Service Bulletin No 105/93 SWIFT

BULLETIN No BE 105/93 SWIFT

Strengthening of the structure of the pedal arms in the rudder control system

Indicatory sketch:

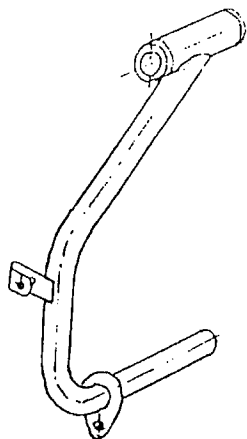
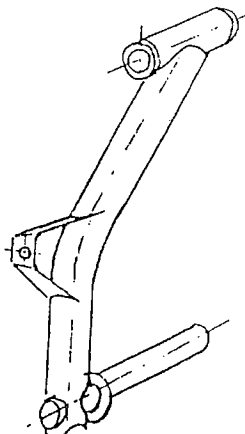
The pedal arm (drawing A/2-1.05.100) has been strengthened by means of enlarging the diameter of tubular element, and also the type of steel has been changed to obtain greater stiffness, strength and material plasticity.
